**CITY OF FREDERICKSBURG LANDFILL
TCEQ PERMIT NO. MSW-1995
GILLESPIE COUNTY, TEXAS**

**PERMIT MODIFICATION
ATTACHMENT 12B
LANDFILL GAS MANAGEMENT PLAN**

Re: Permit Modification – Attachment 12B
GP-6 LFG Remediation Plan - LFG Cut-off Trench & Vent Installation
City of Fredericksburg Landfill – Permit No. MSW-1995
Gillespie County, Texas
RN102211844/CN600527238

WWW.WCGRP.COM **FIGURE G-1**

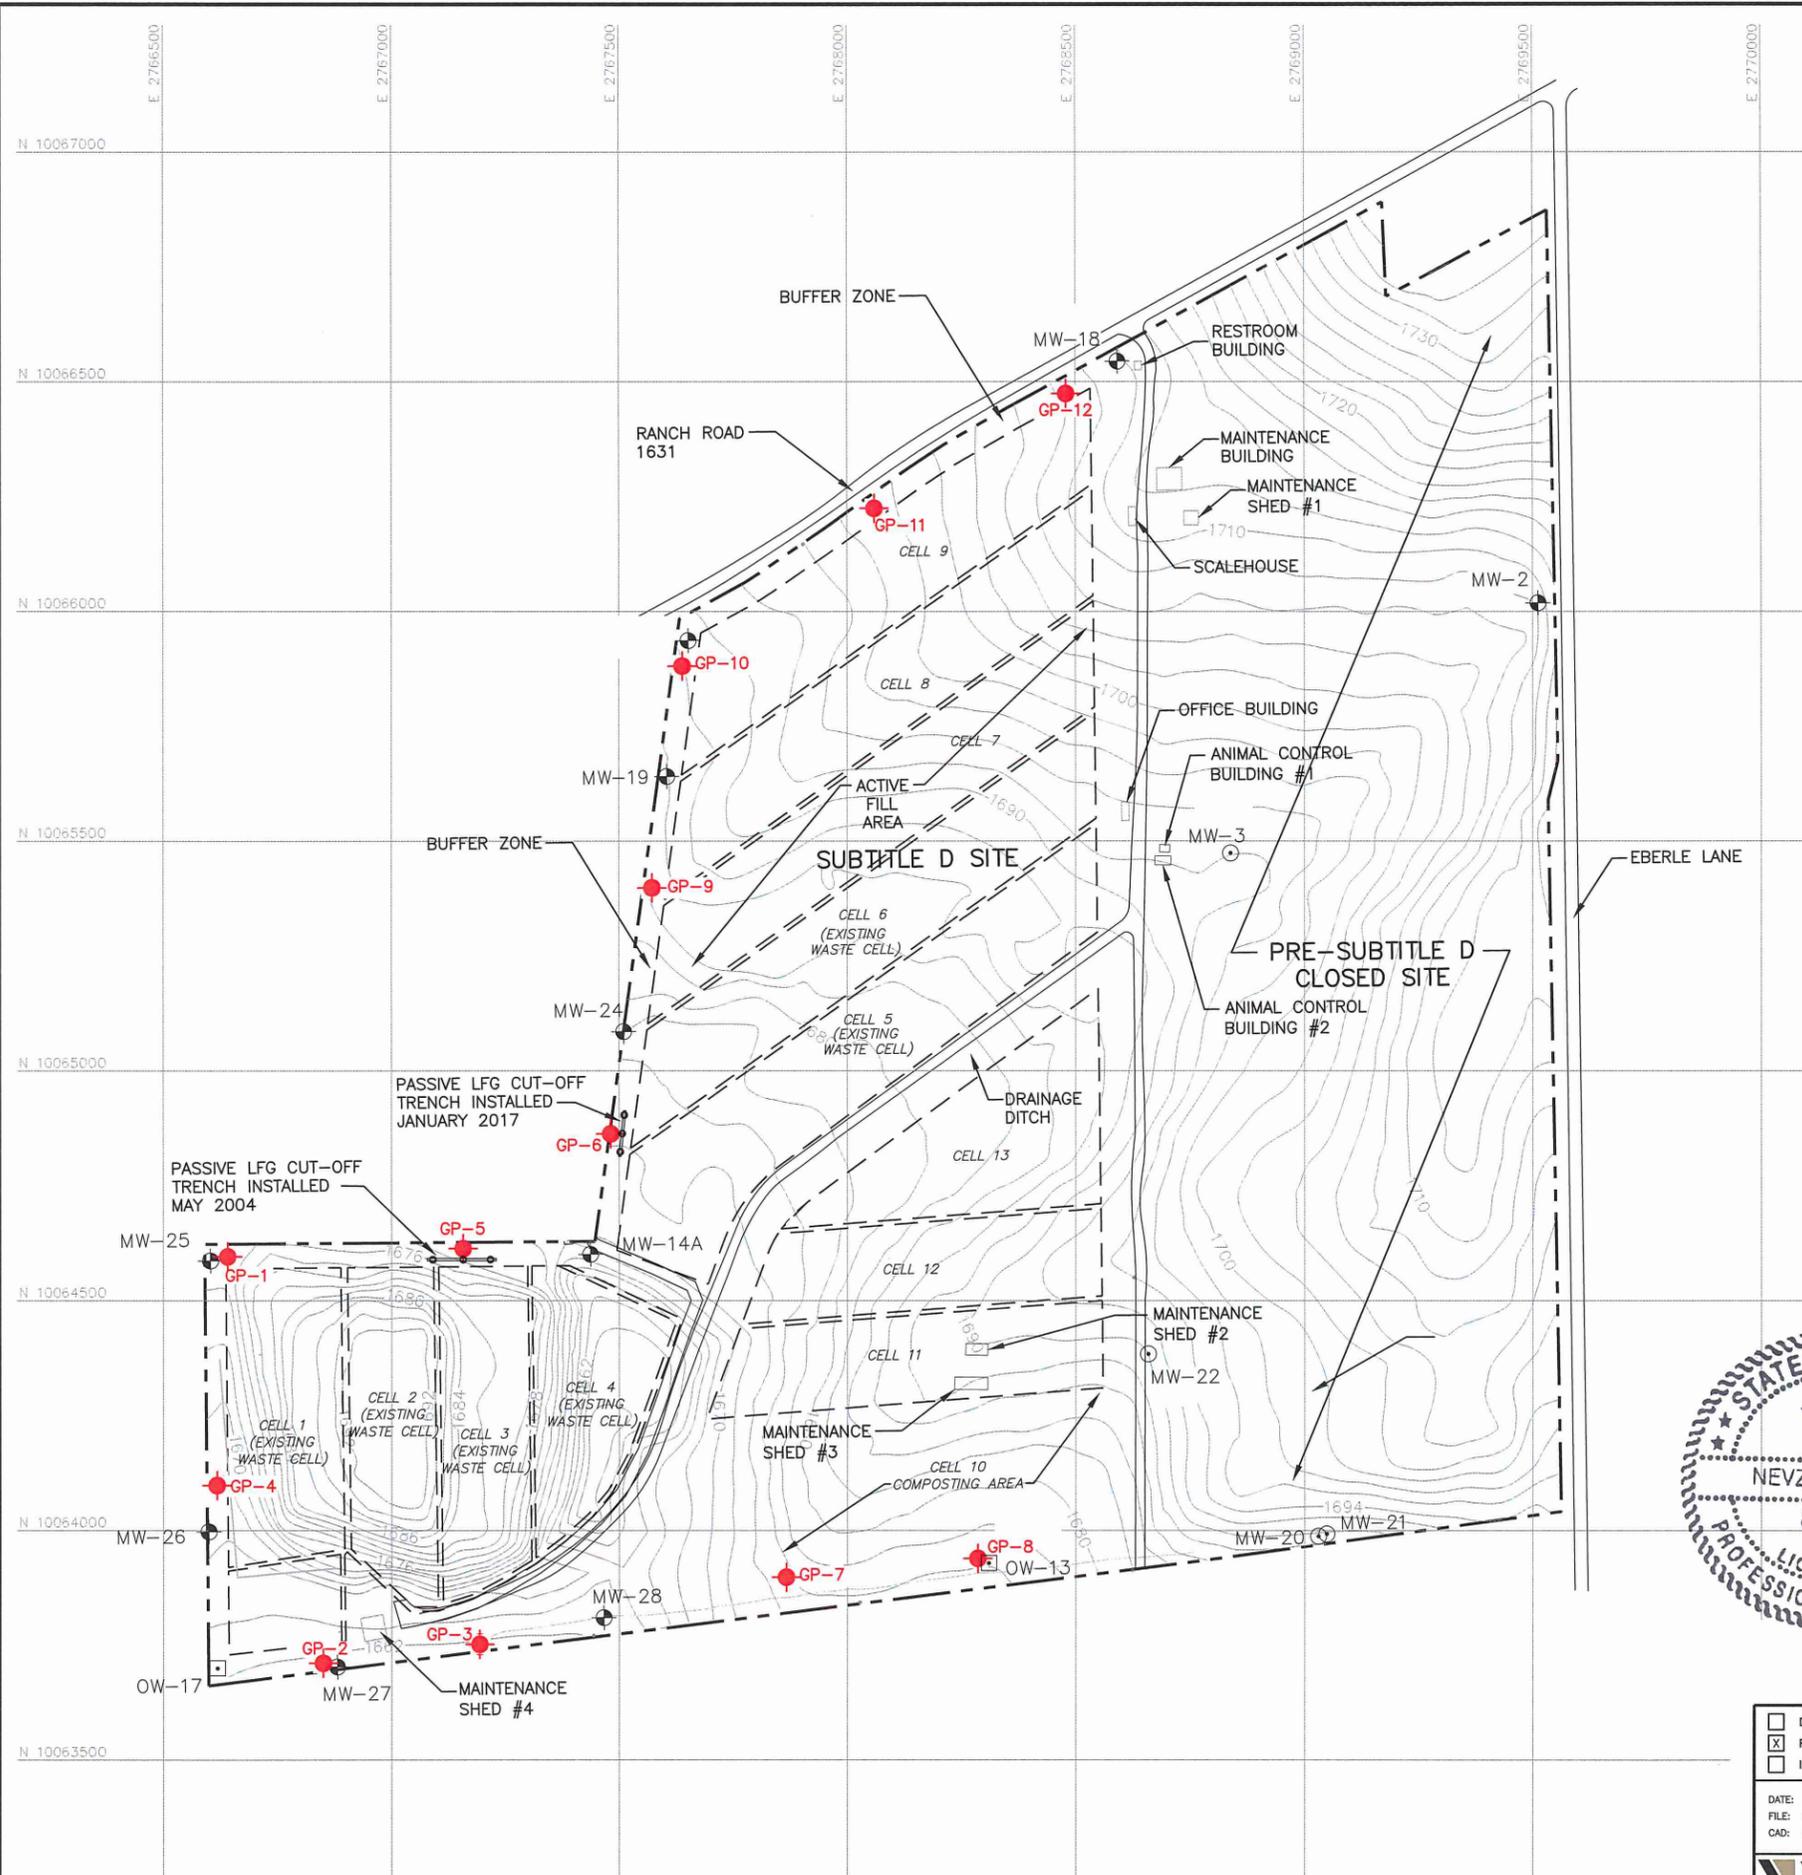
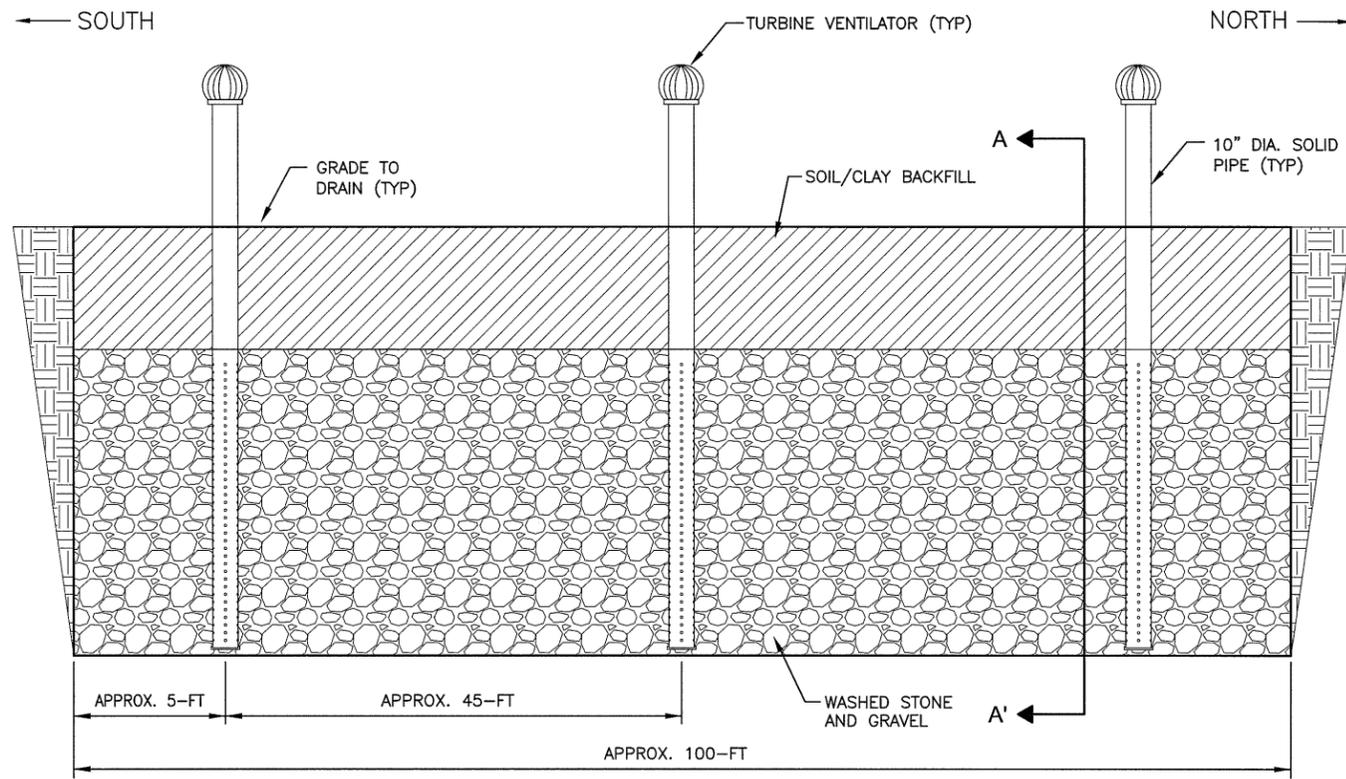
- Appendix G of Attachment 12B has been added to include an updated site map (Figure G-1) and the GP-6 passive LFG cut-off trench and vent system details (Figure G-2).

As shown on Figure G-1, the passive LFG cut-off trench and vent system was installed adjacent perimeter LFG monitoring probe GP-6 to remediate LFG migration in the vicinity. The trench vent system was installed between the limits of waste and perimeter probe GP-6 and completed as shown in Figure G-2. Barhole probe readings taken in the immediate area around GP-6 indicate that the extent of the installed trench is sufficient for the impacted area. The first monthly remediation methane monitoring of probe GP-6 was performed on January 30, 2017. No methane was present in probe GP-6 during the January 2017 monthly methane reading. The facility will continue methane monitoring of GP-6 on a monthly basis until six consecutive compliant methane readings are obtained. The LFG Remediation Plan for GP-6 is further discussed on page 13 of the attached LFGMP permit modification.

1. NEW DRAWING ADDED.

NO.	DATE	DESCRIPTION				
NO.	DATE	DESCRIPTION									
Weaver Consultants Group TBPE REGISTRATION NO. F-3727		WWW.WCGRP.COM	FIGURE G-2

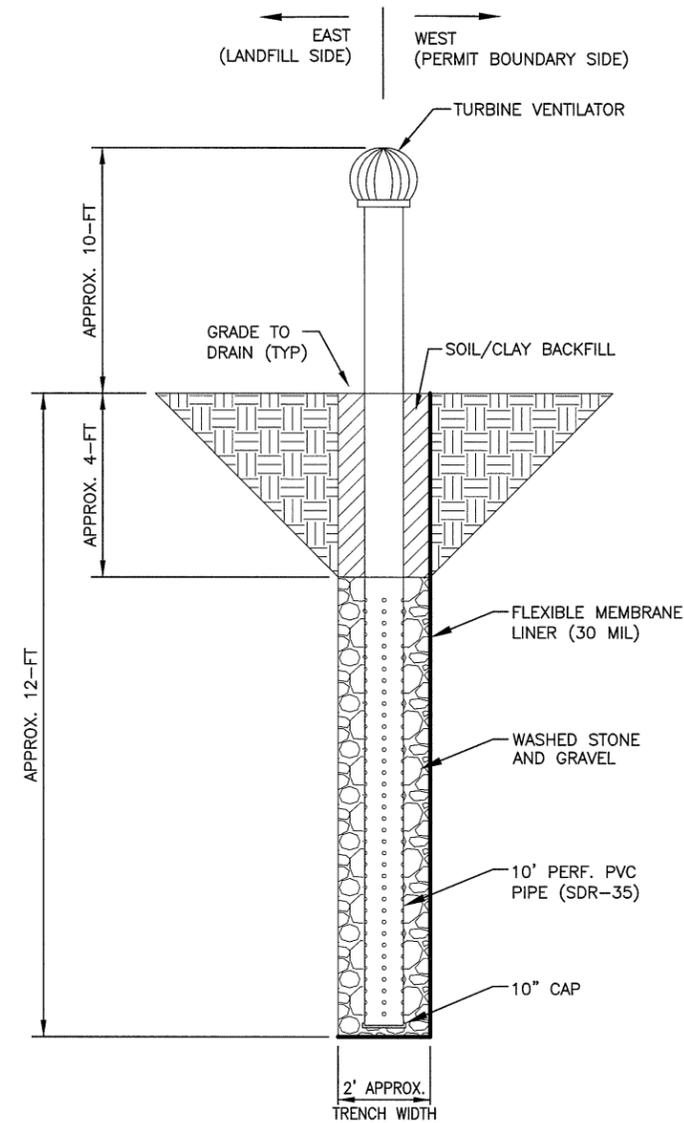
1. NEW DRAWING ADDED.
